Hybrids Phase III: Manual 10 and 14D Changes

Reliability Standards and Compliance
Subcommittee

May 9, 2025

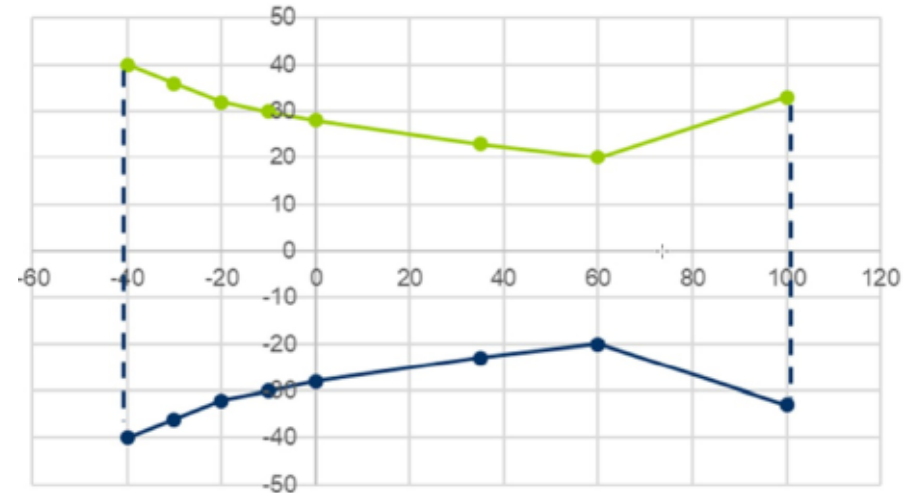
- Section 13.1 Marketing and Classification of Mixed Technology Facilities
 - Modified language to broaden eligibility to participate as a Hybrid Resource
 - Clarified classifications of open-loop and closed-loop based on definition changes
 - Updated language and diagram to be inclusive of all eligible resource types for hybrids
 - Updated language to specify when a Mixed Technology Facility must participate as a Hybrid Resource
 - Noted classification of closed-loop for any Hybrid Resource without storage component
 - Clarified that for all Mixed Technology Facilities participation change notifications must be made no later than six (6) months in advance of its initial start in the energy markets.
